Seattle Design Commission

MINUTES OF THE MEETING

January 17, 2008

Projects Reviewed

Figure 1: Pedestrian overpass concept design.

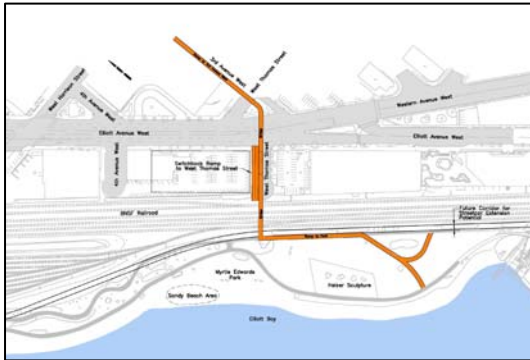
The Commission thanks the team for their presentation, and while the Commission supports this project as a whole, it unanimously does not approve schematic design of the bridge alignment based on the following comments:

- Concern about moving forward into future design phases if this is the design due to current funding situations
- Concern over the level of detail presented, making it hard to review and feel it is lacking compared to past presentations. Contents shown a year ago offered more detail than presentation materials today.

- Regret that efforts put into preparing materials for the artist weren't brought to the table to understand the current level of design and detailing
- Concerns over crossing over Elliott, yet also understand the need to avoid a signalized crossing at Elliott.

- Concerns about future phases of the project without the accessible access point at Elliott
- Images of how the structure crosses Elliott are critical to understanding the project and the urban design merits, and must be displayed

- Suggest reconsideration of the phasing that includes phasing the Elliott crossing rather than the Elliott access point
- Great concerns about the safety for cyclists and pedestrians, especially at the corner intersections and 90 degree bend as the trail enters the park. Flaring, nodes, or other means of wider passage, including a belvedere or some means of respite, would add function, safety and good design

- Suggest the study of potential for simplifying the ramp alignment to the mound to avoid unnecessary kinks and cost in the project.
- The sloping mound as a starting point for the ramp is seen as a positive and unobtrusive element.

- The quality and application of utilitarian detail should achieve a higher standard than the images shown; learn from examples like the adjacent Sculpture Park.
- Utilize this as an opportunity to complement the Heizer Sculpture.
- If there is not going to be a multi-use trail, then regrade is recommended.

- Walking through the images and plan, how does the overpass thread over the potential streetcar route and bike trail?
 - The bridge will extend about twenty feet beyond the trolley fence line and the ramp will be offset by the bridge centerline.

- It is hard to tell if the two girders dead-end in space, with a concrete slab beyond that.
 - Yes, they do.
- Is there a highway pass over the bridge? Will those be detailed similarly? Is there a single concrete pier?

- Is there a baseline?
- Regarding the ramp east of Heizer, could the angle be more radial with a gently curved segmented precast?
 - That would be a cast in place solution, which would not be in the budget. Yes, the team will make it more round horizontally

- There are three aspects to the overpass, which include the part where it crosses Elliott that is visually significant, where it crosses the BNSF tracks that is less visually significant, and where it comes down to Myrtle Edwards Park. The path was created for bike ramps with the idea to cross Elliott and land gracefully in the park. However, pedestrians now cannot access a graceful arc across Elliott (steel with curve). Would value engineering permit access from the west side with steeper ramps?

- The pier is 2.5 feet diagonally and will be round.
- Is there a stair tower at the corner?
 - There will be an open belvedere with a flare at the bridge.

- Yes, this ramp is at 5% but can increase to 8.3% which require landings that need to be 10 feet wide.
- Feel that the project is underfunded and worried about moving forward.
